REZONING APPLICATION

PROPERTY INFORMATION			
Project/Property Address: Morse Road <i>5503 Morse Rd</i>		Project Name/Business Name: Morse Road 14	
Parcel #: 025-011219	Current Zoning: (see <a href="#">Map</a> )	<input type="text" value="ER-1"/>	Acreage: 13.96

Re: Resubmission for Morse Road Multi-Family Development

**CONCEPT PLAN**  
**MORSE ROAD**  
 S03

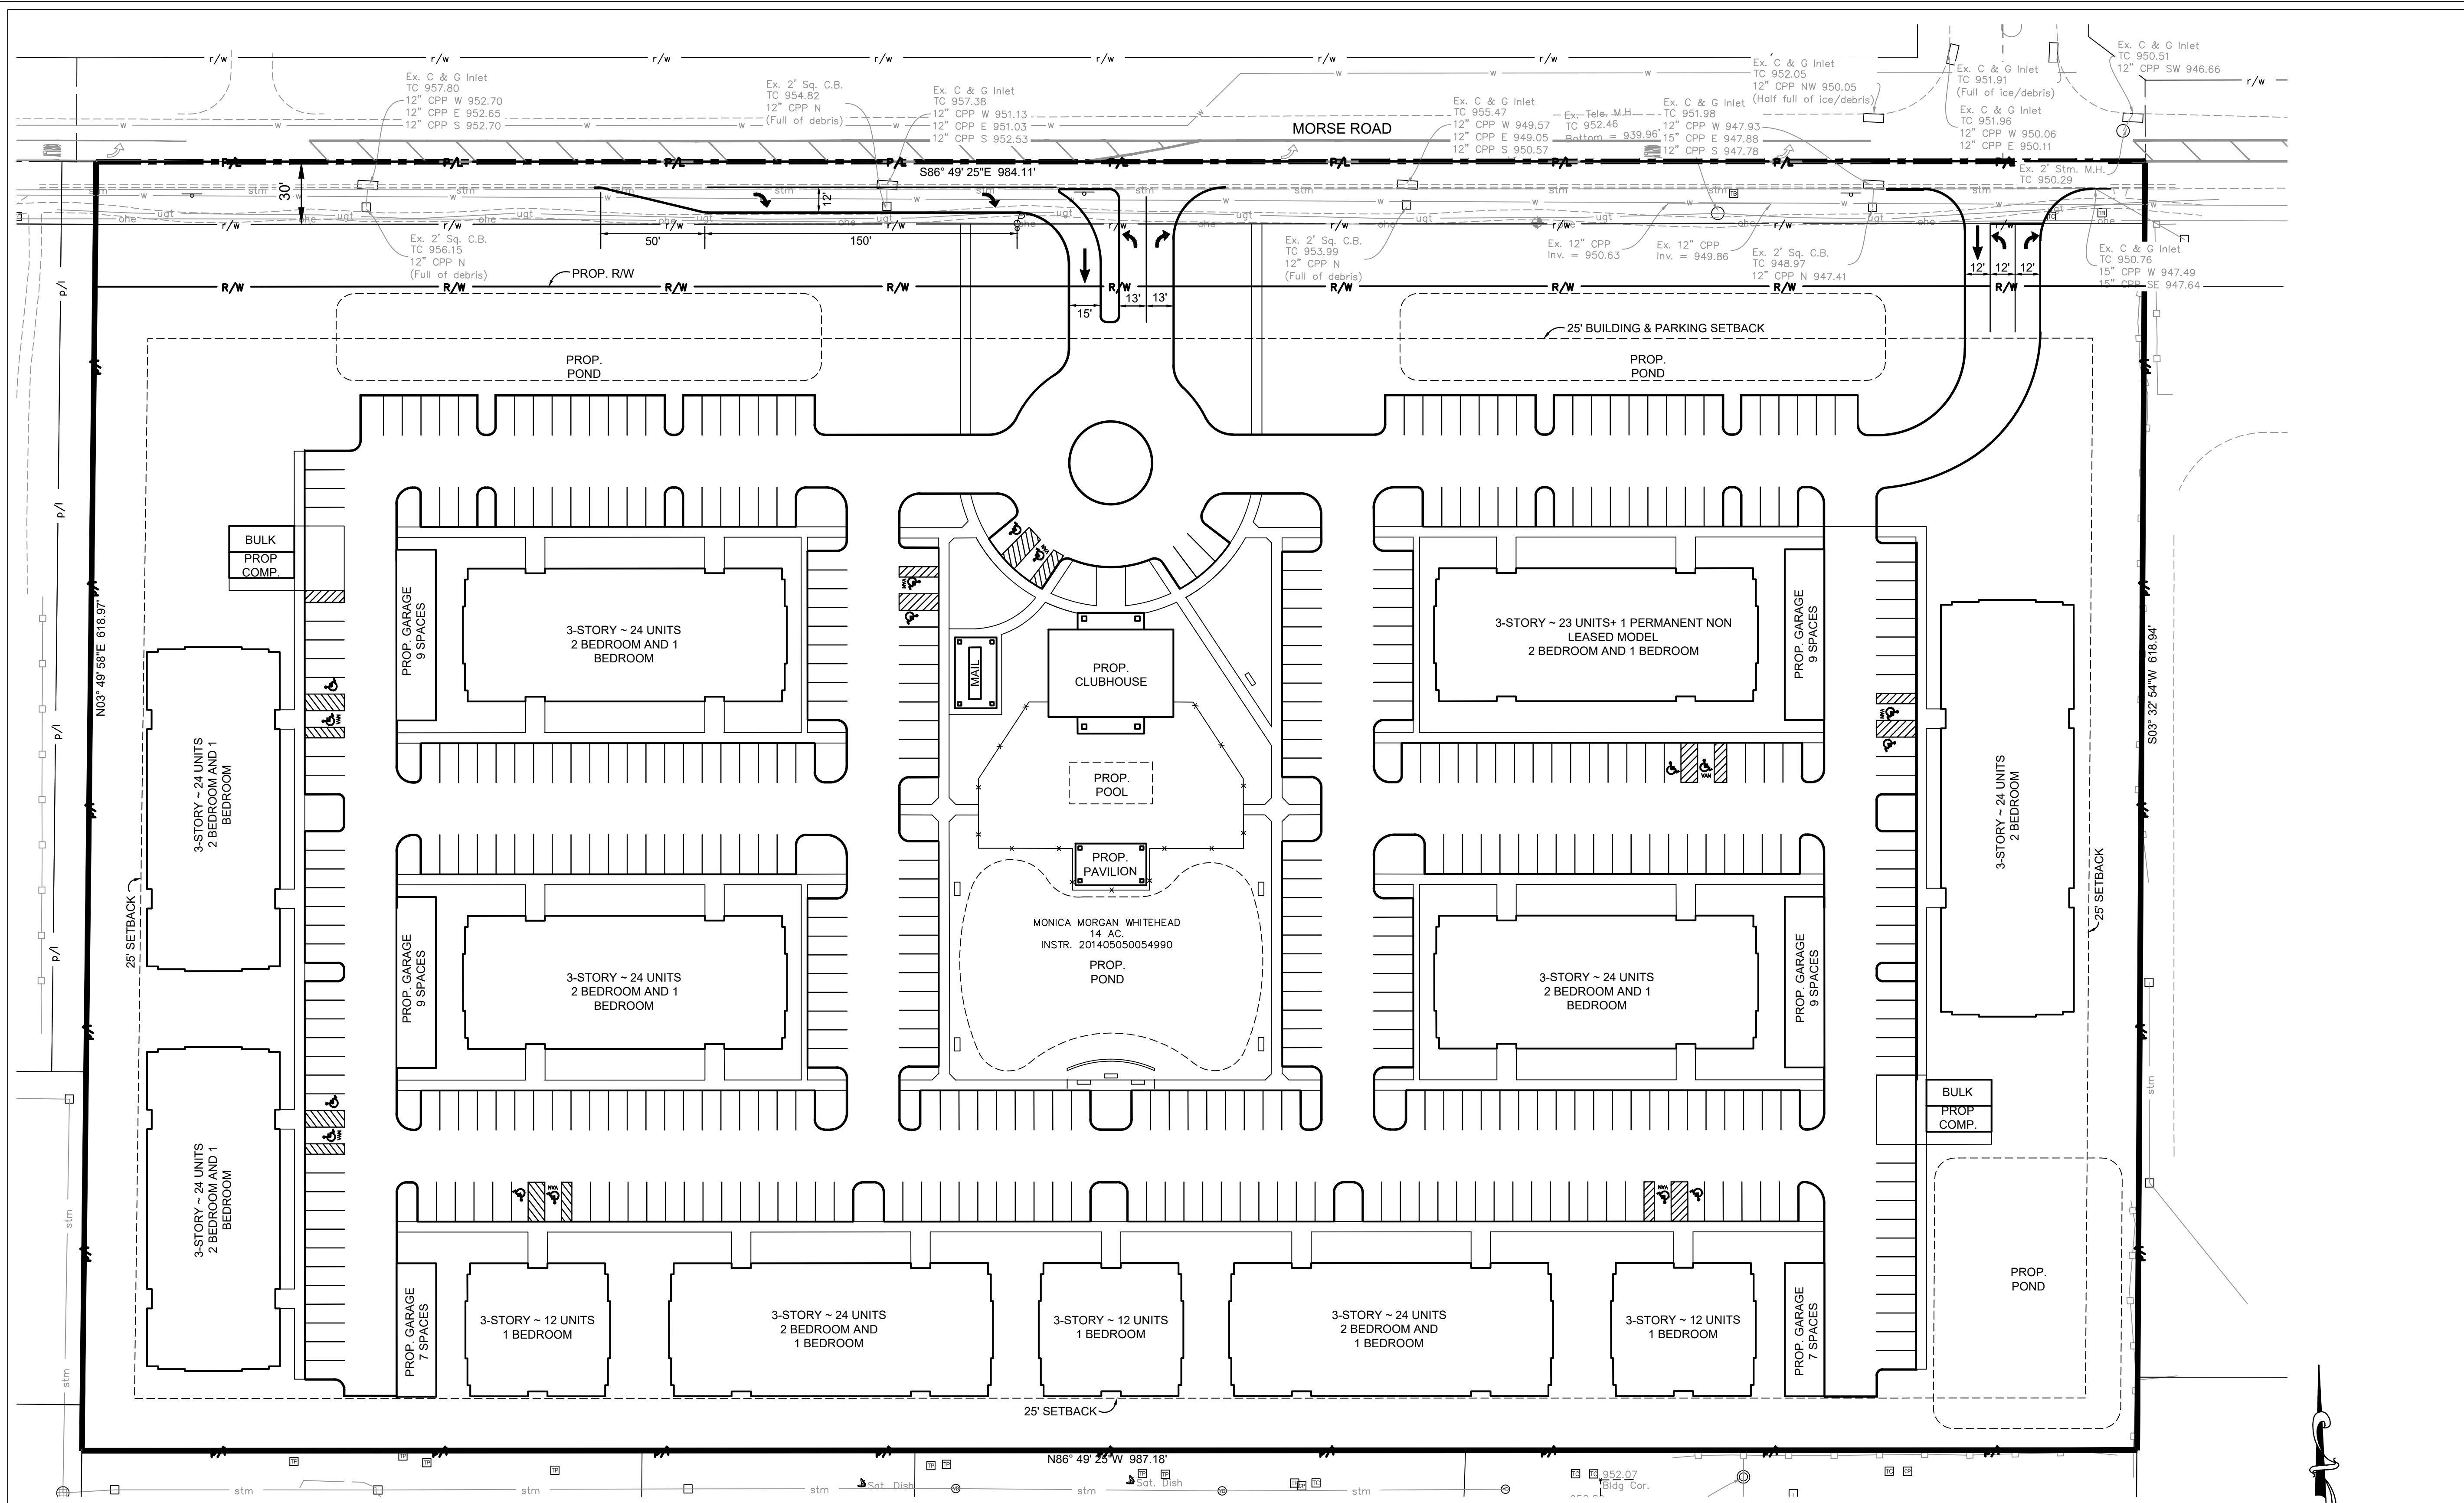
3. *Informational Comment* - The setback of 25'-0" is noted. The setback shown on the revised site plan is 25'-0" from the newly required right of way. From the City engineering comments a new right of way dedication will be required with 60'-0" from the centerline of Morse Road.

10. Please reference the herein attached revised site plan for the development. The total proposed number of units is now (251) with (1) permanent non leasable model. This is within the density permitted of 18 units per acre. Please also note that the total number of parking spaces now provides a minimum of 2 parking spaces per dwelling unit.

Our site plan has been revised to show a total of 251 units which is within the permitted density of 18 units per acre. Please note that the developer will have one non leasable permanent model that will be located close to the clubhouse and leasing office. Please disregard our previous site plan submissions and review only the attached site plan which is dated June 9, 2022.

The site plan has also been revised to respond to the engineering review regarding the required 60' dedication corridor along Morse Road. This is consistent with the City of Columbus Multimodal Thoroughfare Plan.
